## SUBDIVISION REVIEW SHEET

**CASE NO.:** C8-2022-0221.1A

**SUBDIVISION NAME:** River Park South

**Exhibit C: Master Comment Report**  
**CITY OF AUSTIN –DEVELOPMENT SERVICES DEPARTMENT**  
**SUBDIVISION APPLICATION – MASTER COMMENT REPORT**

Exhibit B: Proposed Final Plat

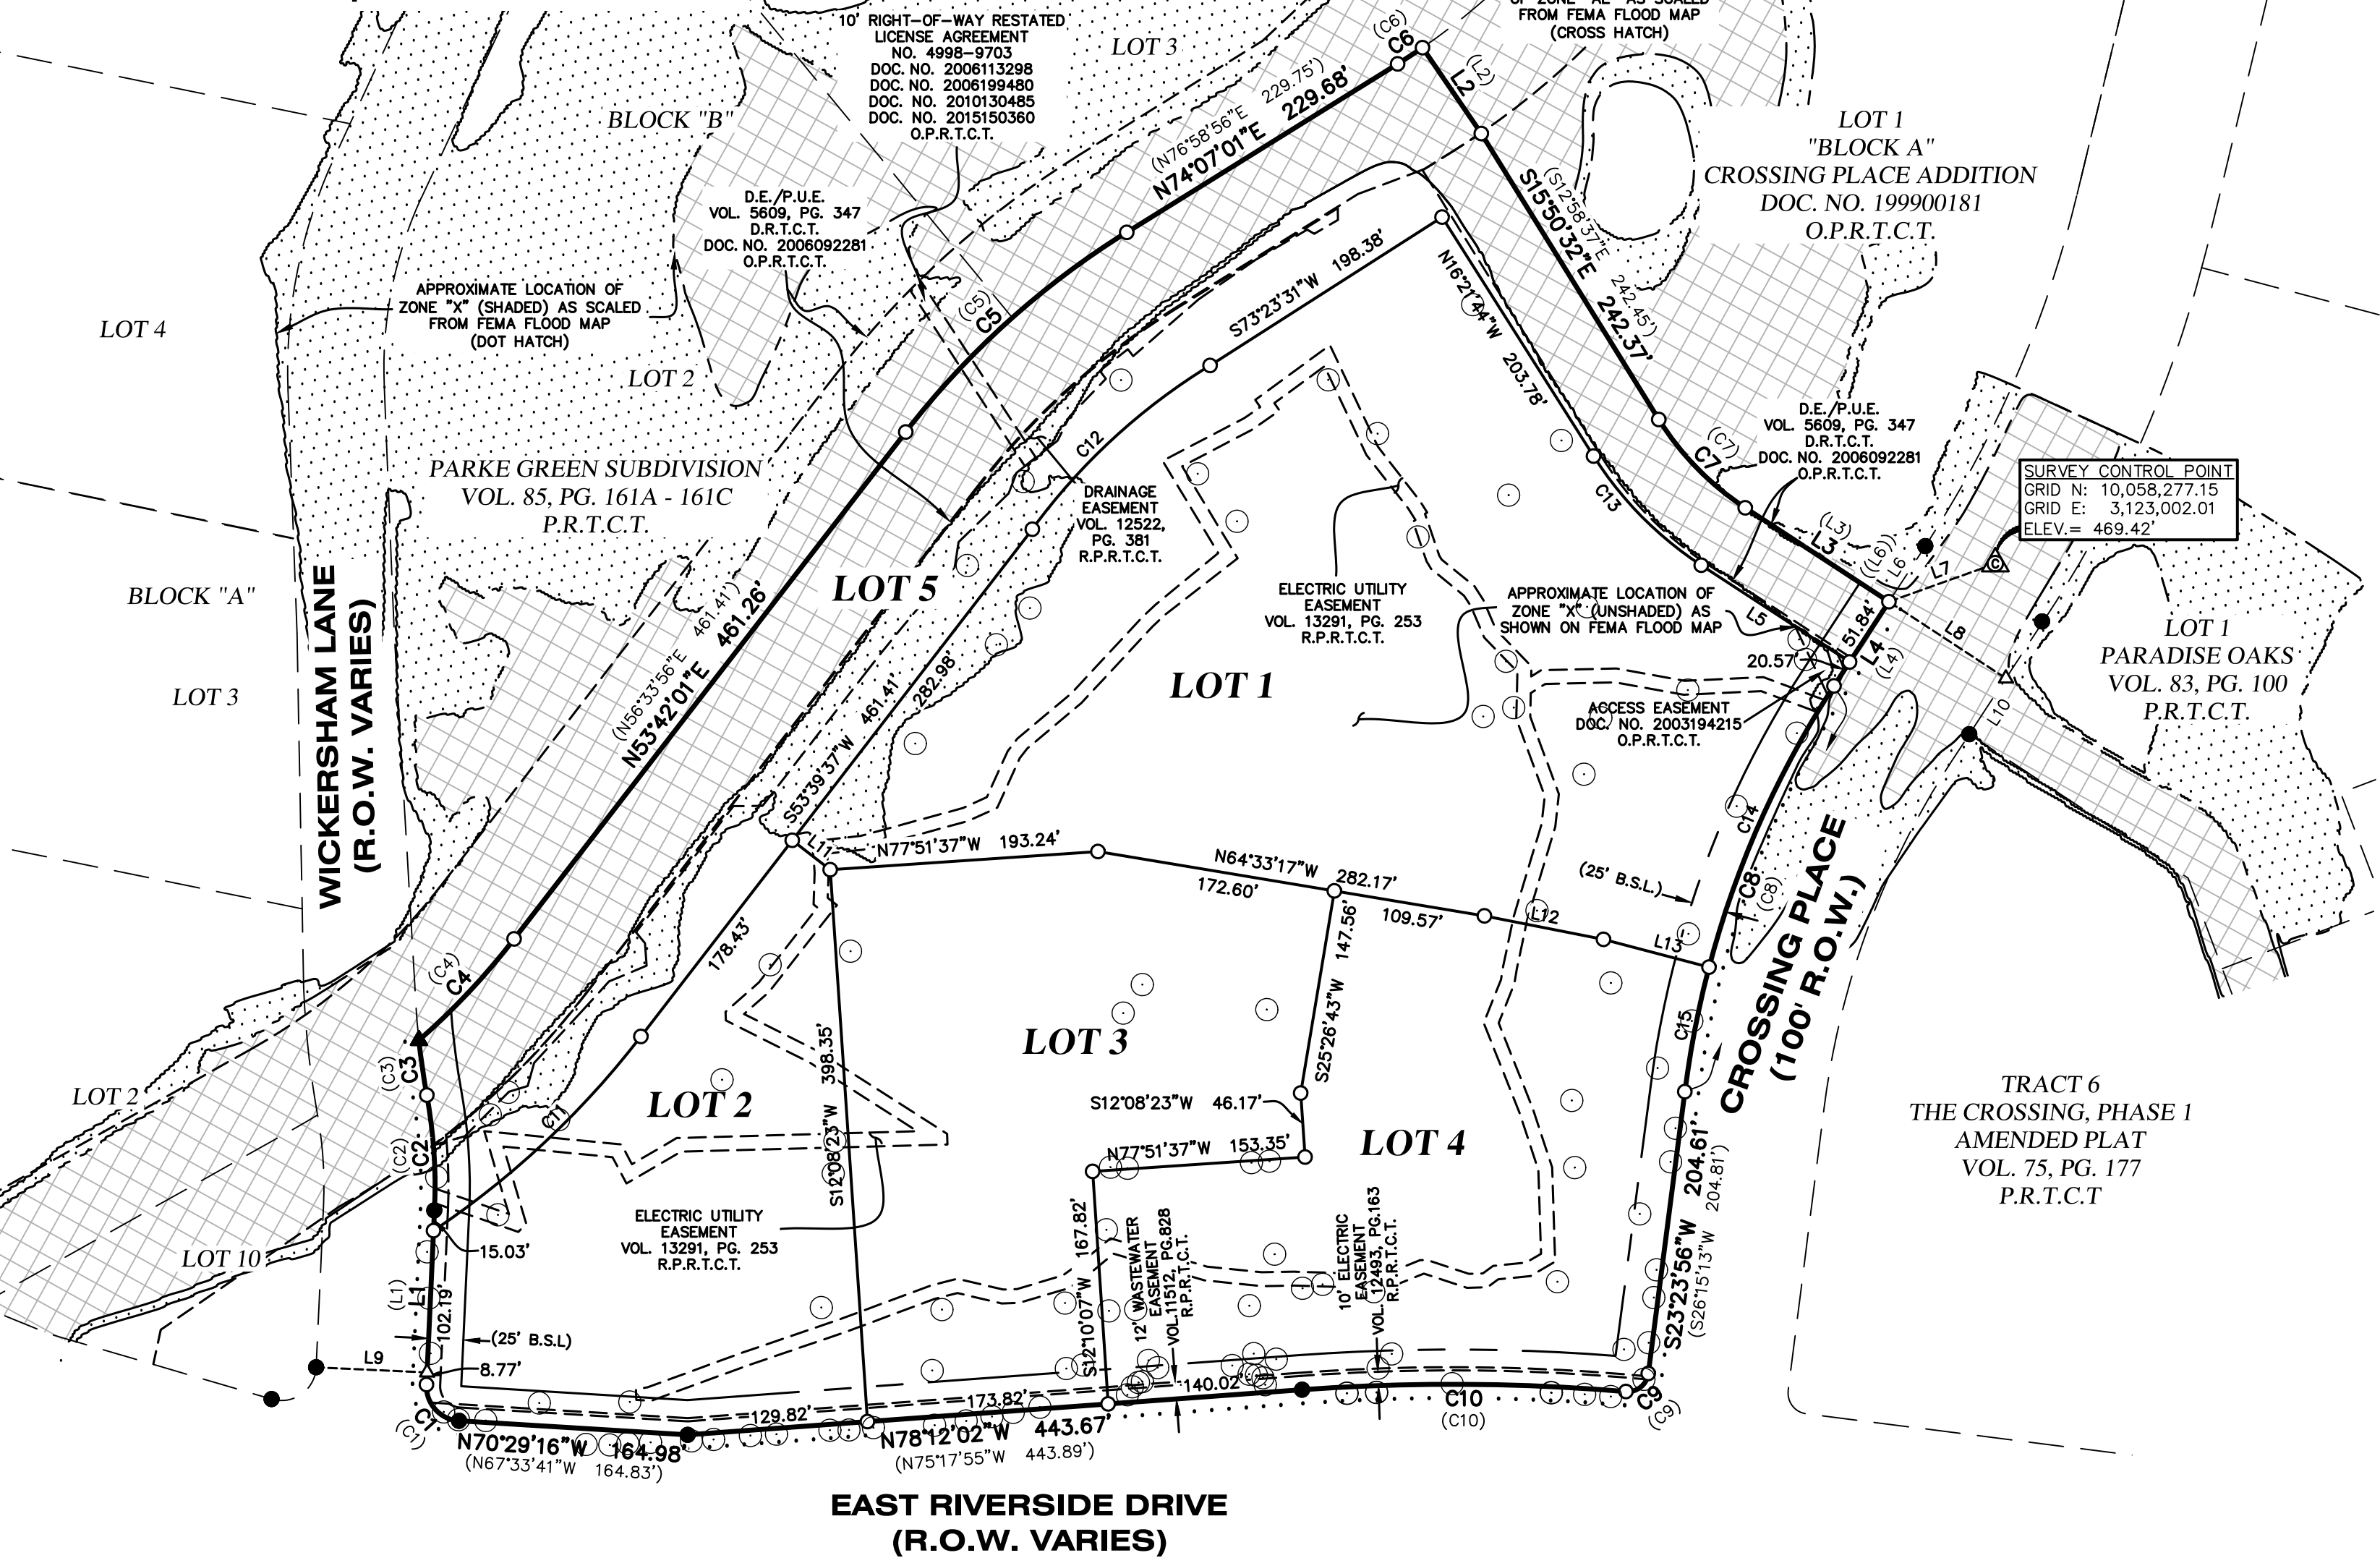
**SR3.** What are all of the circles with dots all over the plat? Trees? Please remove from the face of the plat/ plat diagram if these are tree outlines. If not, please define what these are and add these to the legend if appropriate (25-1-83)

**SR6.** It is hard to see the boundaries for the lots – particularly Lot 1, 2, and 5. Please adjust the line width and revise the lines as follows: 25-1-83

**SR7.** What do the different hatchings mean on the face of the plat? Please add each type to the plat's legend (25-1-83)

**SR11.** Remove all building setback lines from the face of the plat and the legend (25-1-83)

**Please show 15' electric easement adjacent to all street R.O.W. approved on preliminary plan C8-2021-0221 on this plat.**

**AW1. Per Utility Criteria Manual Section 2, §25-4, §25-9:**

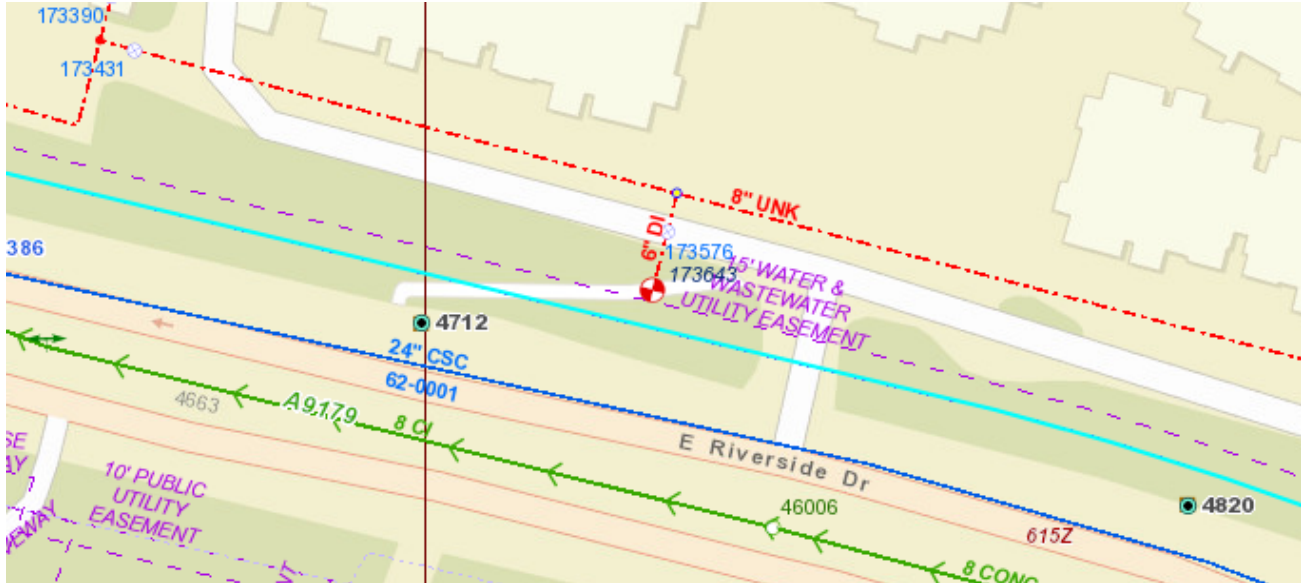
City records indicate the wastewater easement within the boundaries of the plat is a 15' easement, not a 12' easement as shown. Verify easement width. Provide a recorded copy of easement to reviewer if easement is 12' as shown.
